Attachment J3

Submissions

Planning Submission
For: SP 67057: 23 Billyard Avenue, Elizabeth Bay

Development Application ('DA') No. 2023/0727
'Demolition of existing buildings, tree removal, excavation and construction of two new residential flat buildings, 6 to 8 storeys in height, with 22 apartments, 4 basement levels containing 27 car spaces, rooftop terraces, swimming pools and associated landscaping works including new tree plantings. The application is Integrated Development requiring the approval of Water NSW under the Water Management Act, 2000.'

1.15pm Existing

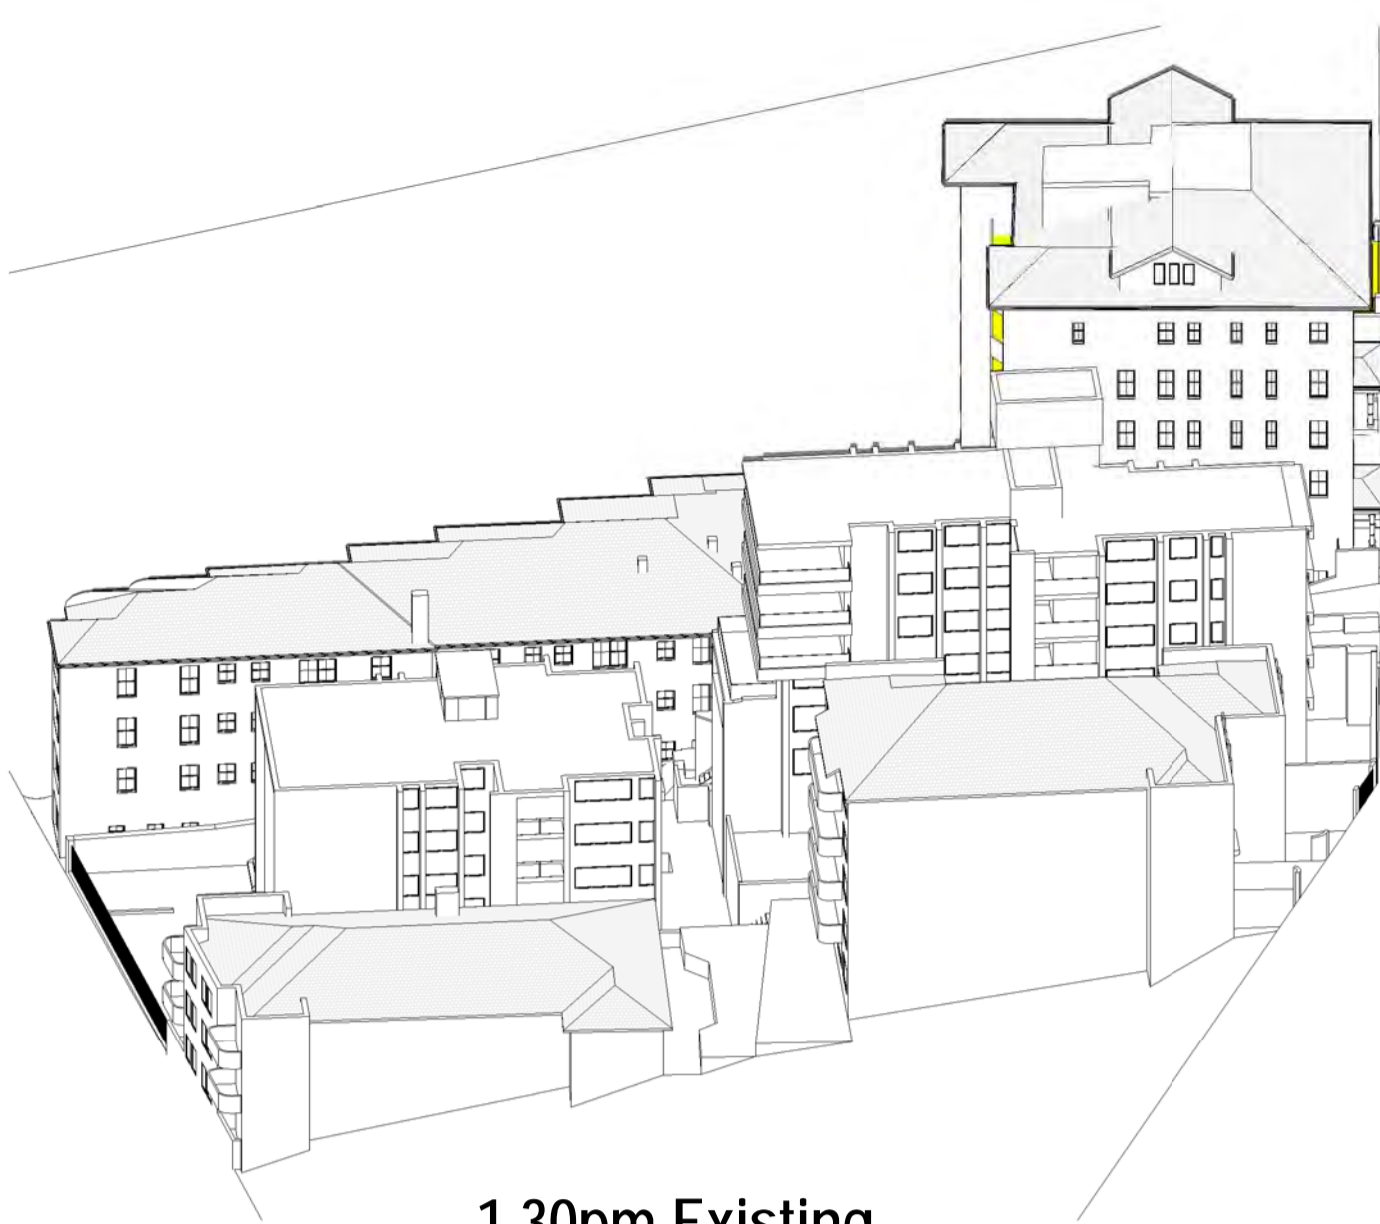
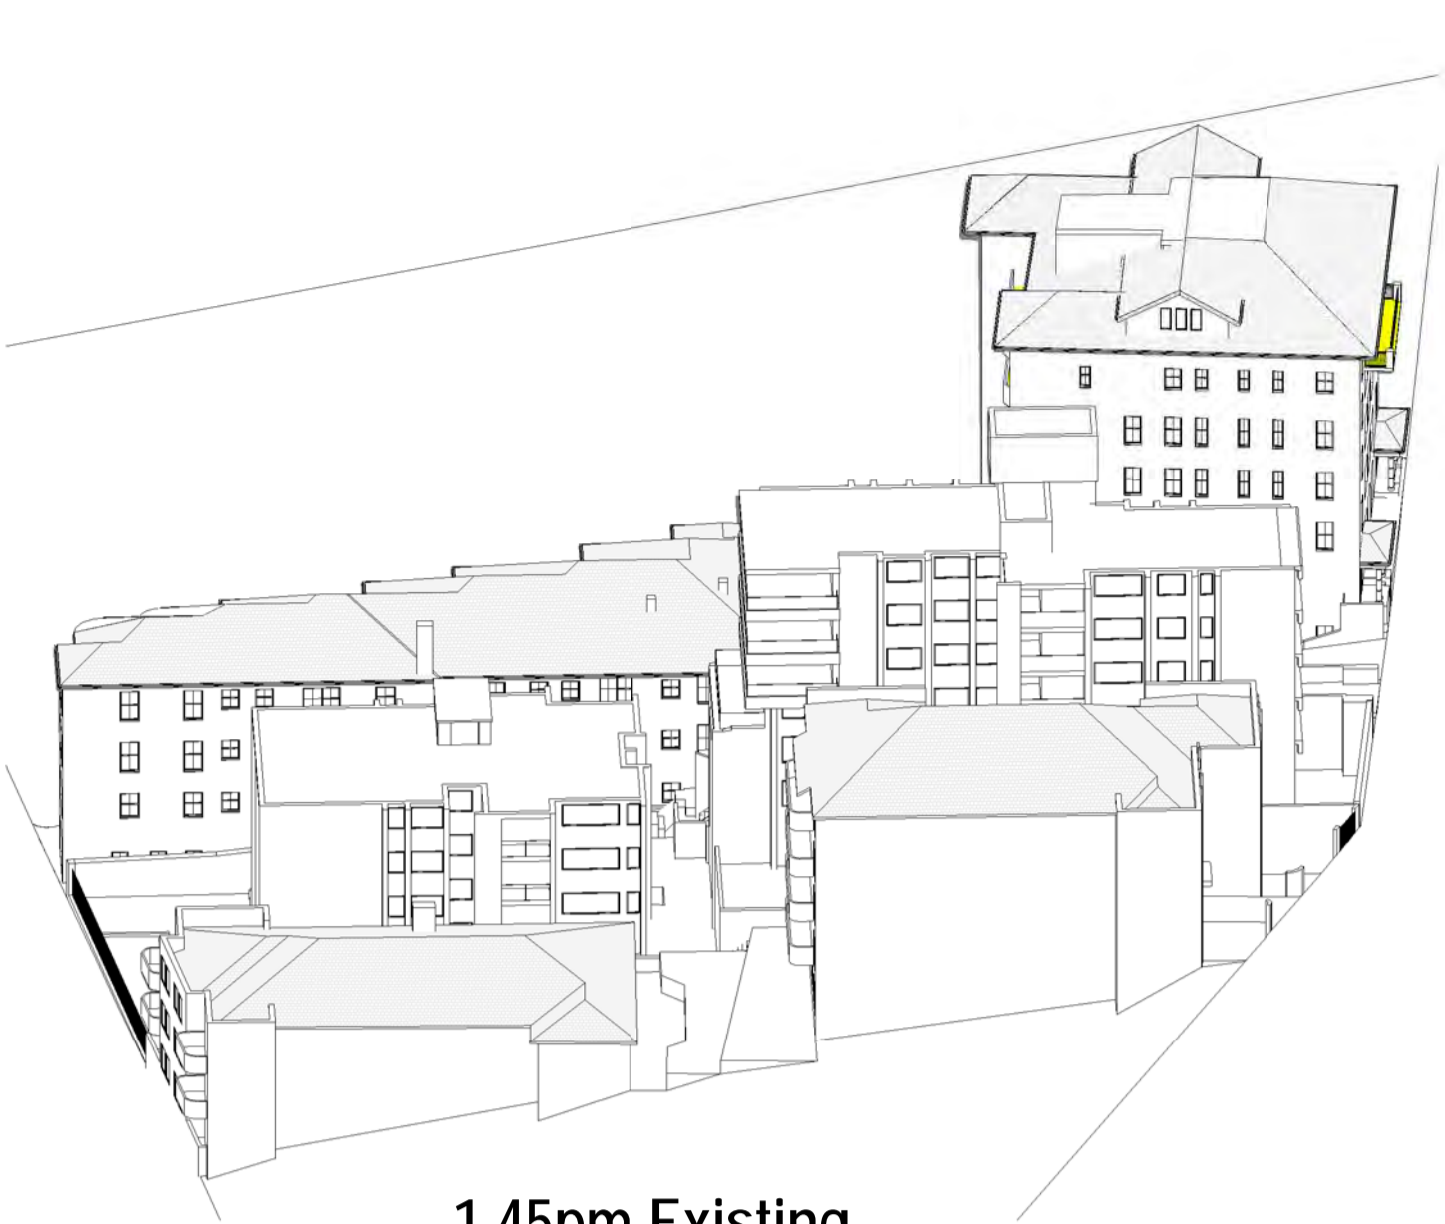
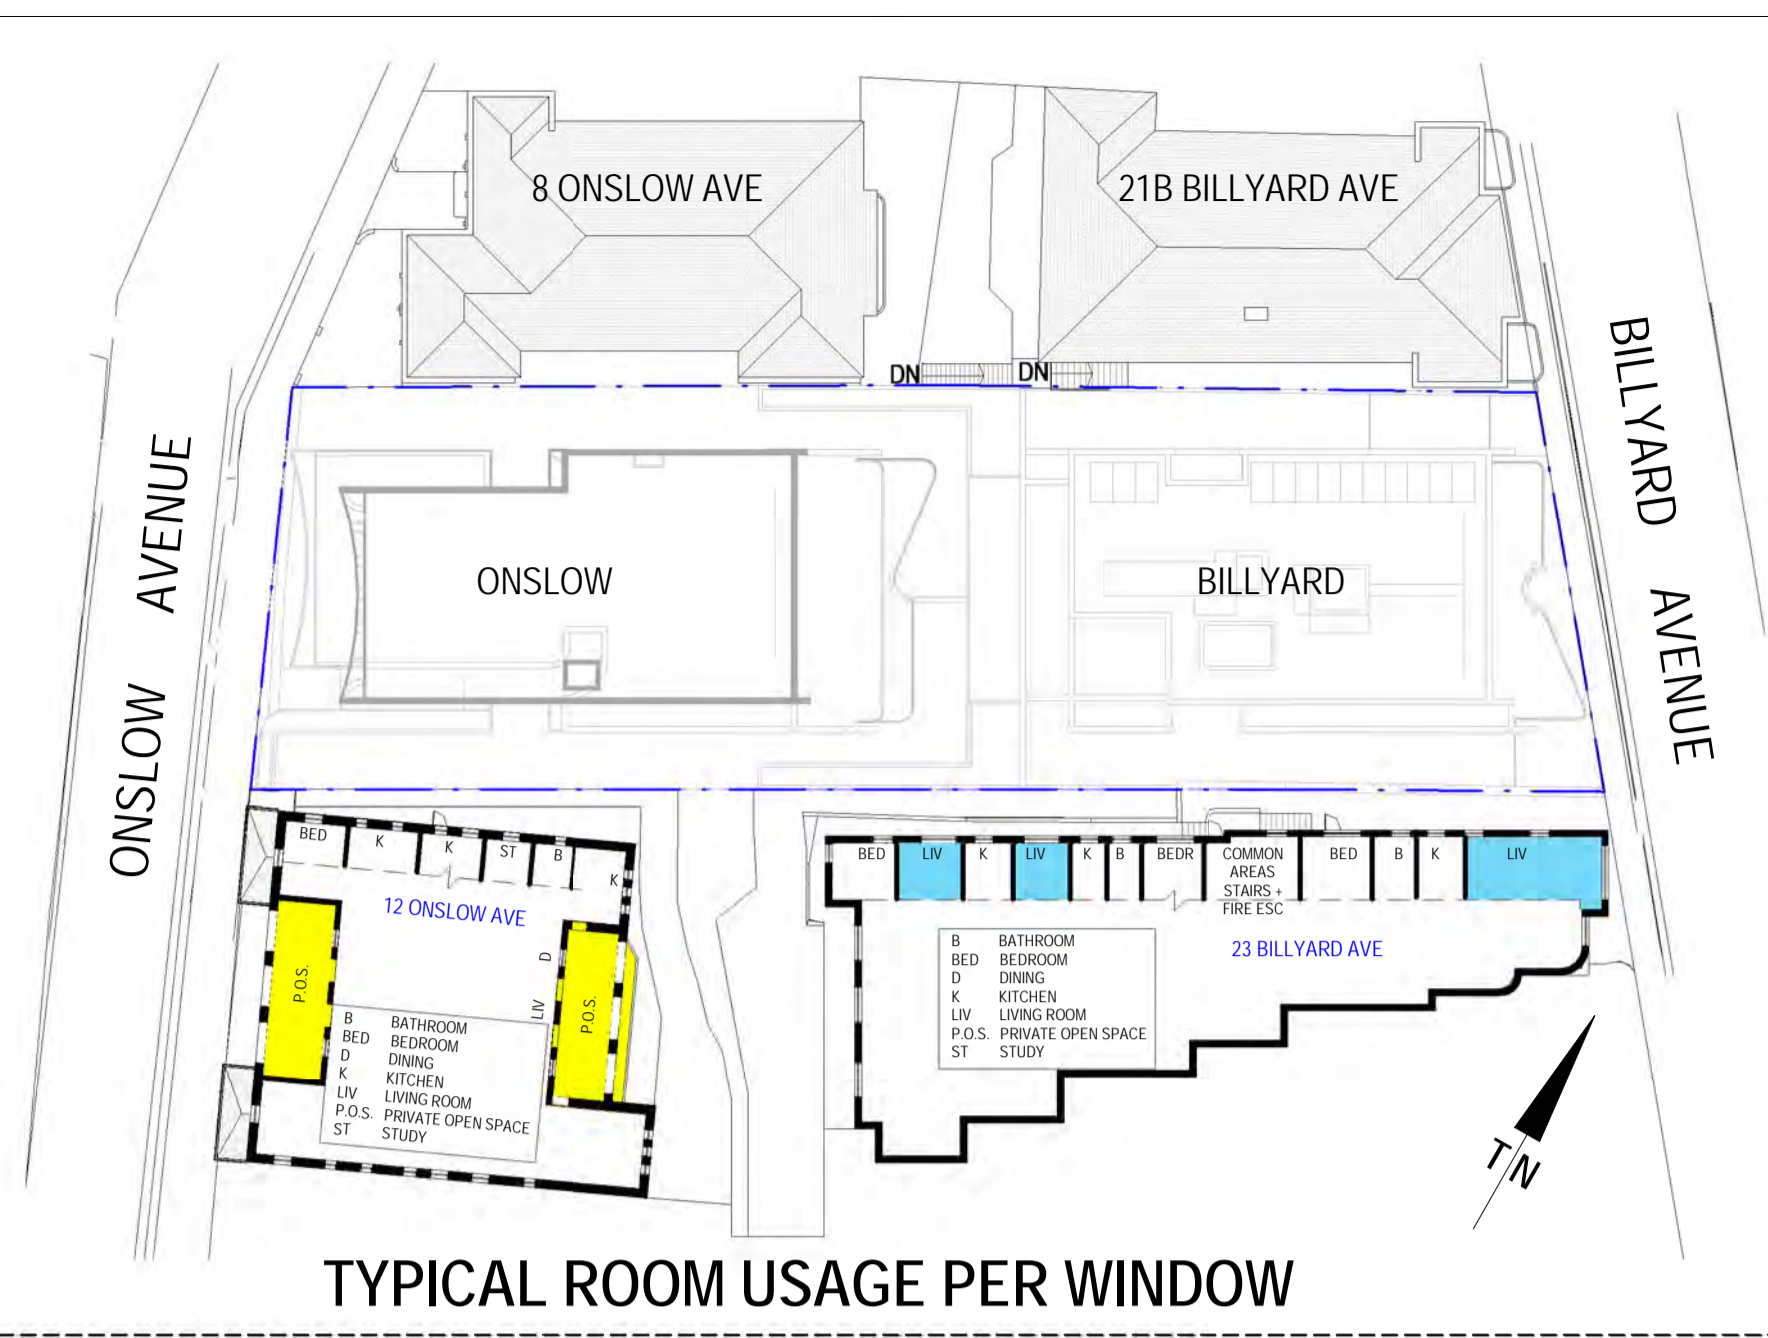
The solar diagrams show worsening of solar access to these only areas of living space (no balconies available). It is noted that staff requested 15 minute intervals and these have not been provided for 23 Billyard Avenue.

9.00AM - 3.00PM				
	EXISTING:	PROPOSED:	ACCESS LOST:	% LOST:
P.O.S.				
LG2 UNIT 1	3.25 HOURS	1.75 HOURS	- 1 HOUR	44%
LG1 UNIT 3	3.25 HOURS	1.75 HOURS	- 1 HOUR	44%
GF UNIT 5	3.25 HOURS	1.75 HOURS	- 1 HOUR	44%
1 UNIT 7	3.25 HOURS	2.25 HOURS	- 0.75 HOUR	33%
2 UNIT 9	3.25 HOURS	3.25 HOURS	0	
3 UNIT 11	3.25 HOURS	3.25 HOURS	0	
4 UNIT 12	4 HOURS	4 HOURS	0
